INSPECTORS REPORT ON A LICENCE APPLICATION

To:	DIRECTORS	
From:	MALCOLM DOAK	LICENSING UNIT
Date:	5 JULY 2005	
RE:	APPLICATION FOR A WASTE LICENCE FROM ROADSTONE DUBLIN LIMITED, LICENCE REGISTER 213-1 , ROADSTONE DUBLIN REMEDIATION LANDFILL.

FIGURE 1 Application Area and Facility Infrastructure Layout:

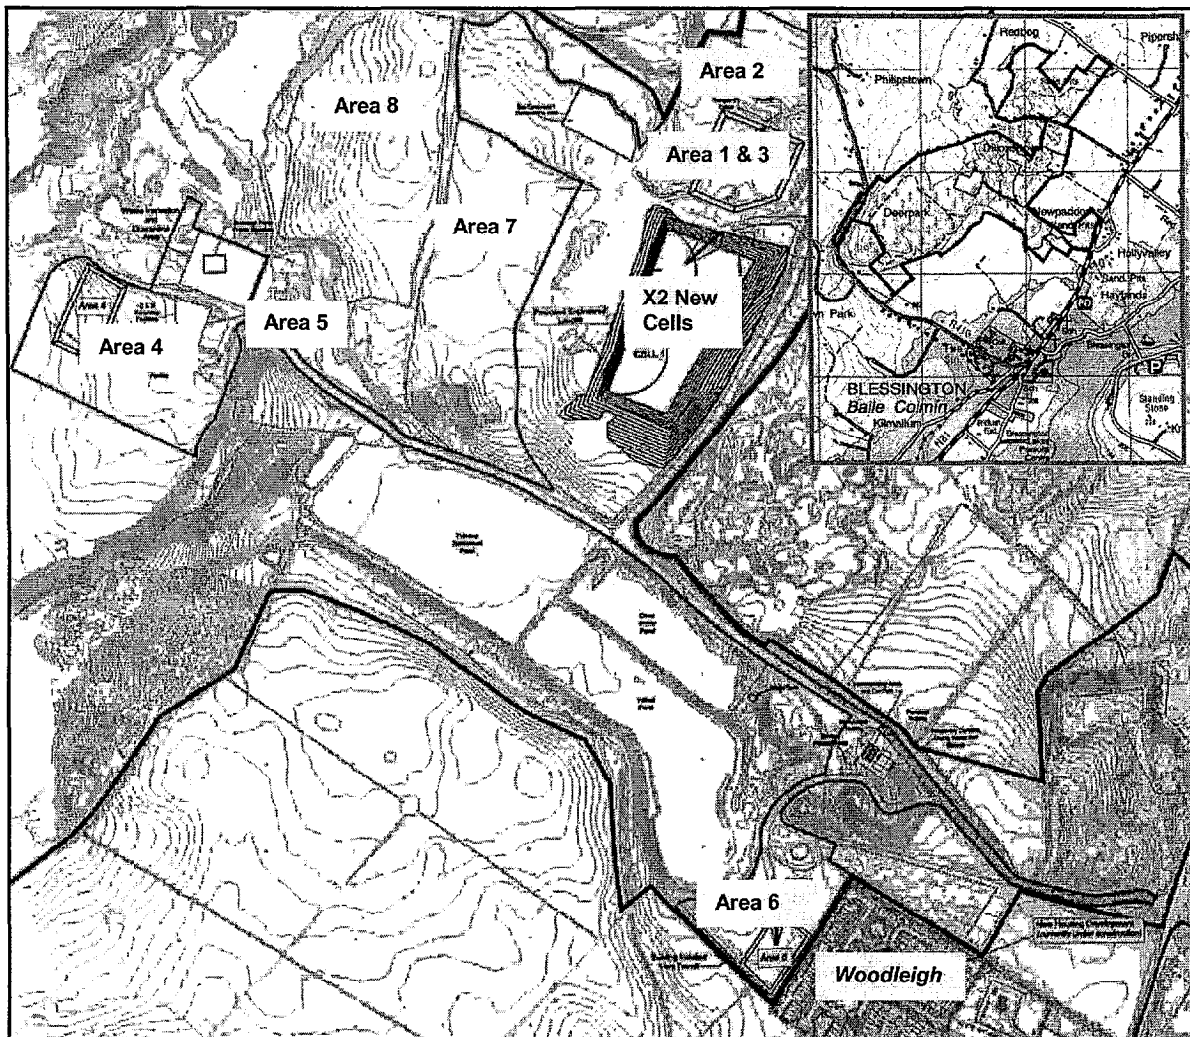
The waste licence application boundary is an irregular polygon (Figure 1 - red line) as proposed by the applicant to incorporate waste activities at the three illegal wastes areas and the construction and operation of the two landfill cells.

The polygon does not provide for any other areas at Roadstone where waste might be uncovered nor the other Areas 2, 3, 5, 7, and 8. The narrow linear aspect of the boundary across the middle of the site is most unusual (it runs west/east between waste between areas 4 and 6 along the haul road). Overall, the irregular shape and dimensions of the waste boundary are not practical.

Figure 2: Groundwater Contour Plan of unconfined aquifer showing groundwater flow from Roadstone is south/southeast to the WCC wellfield and Pollaphuca Reservoir. 25 May 2005 drawing.

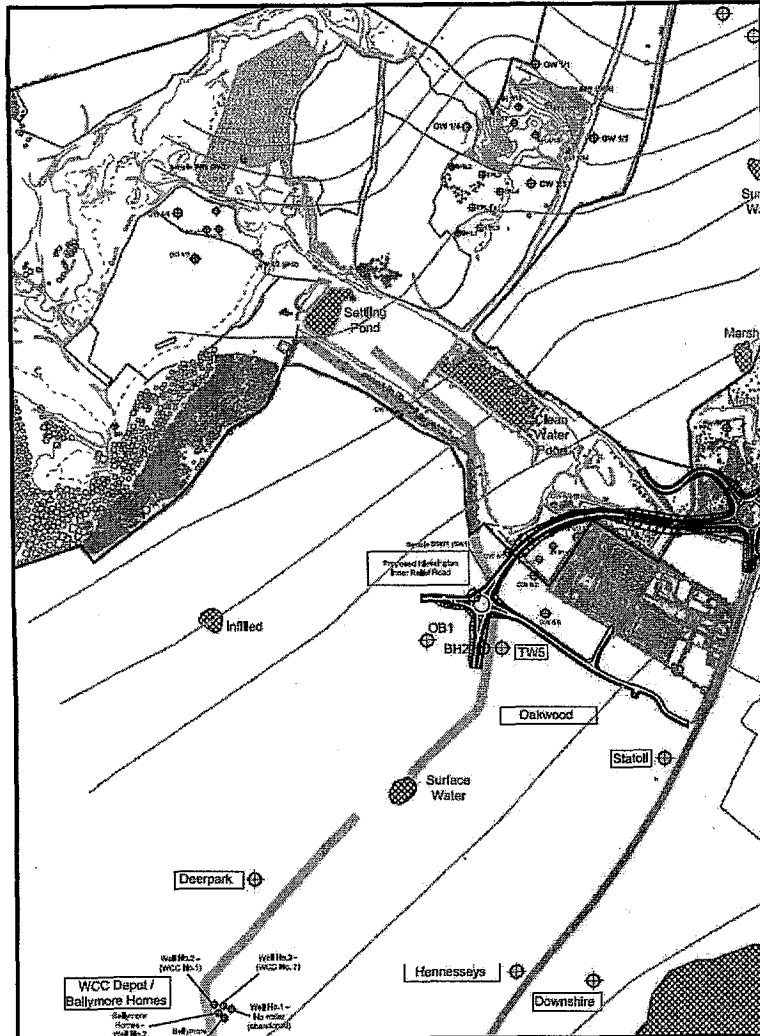
Only after Agency intervention did the applicant assess the impacts the existing waste bodies are having/will have on the numerous wells in Blessington village even once the waste is removed. Information supplied on 31 May 2005 shows that all

abstraction wells in Blessington village lie downgradient/cross-gradient of the Roadstone facility, as indicated in Figure 2:

Figure 3: Capture of GSI web map server showing the groundwater matrix response scores of R3¹ for the Blessington Aquifer (light red ~9km²) and R4 for the WCC wellfield source protection area (dark red ~1.2km²).

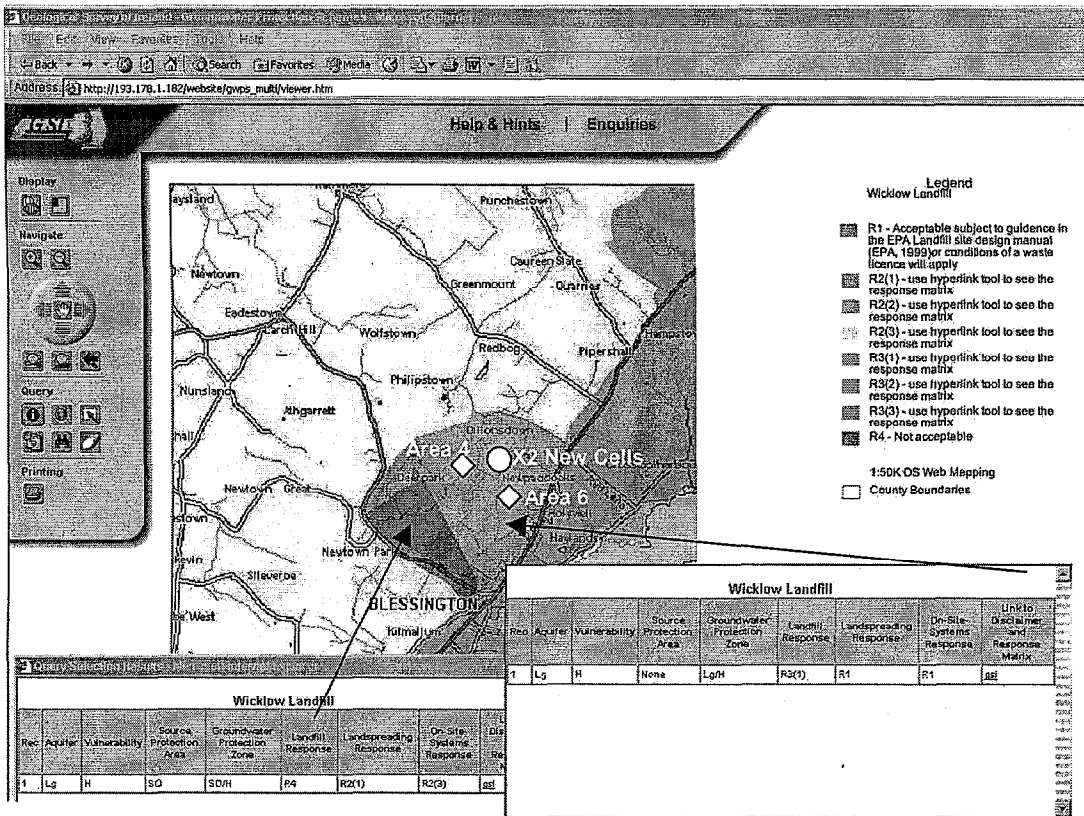
The GSI report¹ and GSI correspondence with the applicant specifies that the Roadstone landholding lies on a **locally important gravel aquifer** with a **high vulnerability**. Further, the GSI has applied a GSI/DOELG/EPA landfill matrix response of **R3**¹ to the entire Blessington Aquifer (see Figure 3), which determines that the siting of a landfill is not generally acceptable unless it can be shown:

Wicklow County Council records show that there are currently six large groundwater abstraction wells either in constant use or occasionally pumped, which supply all of Blessington village with its drinking water needs. Current abstraction rates for the Wicklow County Council wells is 26m³/hr or approximately 230,000m³/year, and a combination of others supplies a further 18m³/hr (160,000m³/year) to the population. The closest abstraction well (single domestic use) down gradient is the 'Murphy House' well situated at approximately 592m south east of Area 1. The 'Deerpark' wells are situated at a distance of 750m south west of Area 6. The wells in the Wicklow County Council yard lie 1160m south west of Area 6, for which the GSI has designated the council depot wellfield as a 'source protection zone' resulting in a large zone of contribution (ZOC) of 1.2km² as per Figure 3 (at 40m³/hr) and an arising **R4** matrix response.

100% dependency of Blessington village on groundwater for drinking water, the high levels of abstraction (c. 500,000m³/year), the large ZOC for the Co. Co. wellfields, the groundwater contours and applicant breakthrough times, I consider that the whole Blessington Aquifer should be designated and given a GSI/DOELG/EPA matrix response of **R4**. No Landfills shall be developed on aquifers with such a rating.
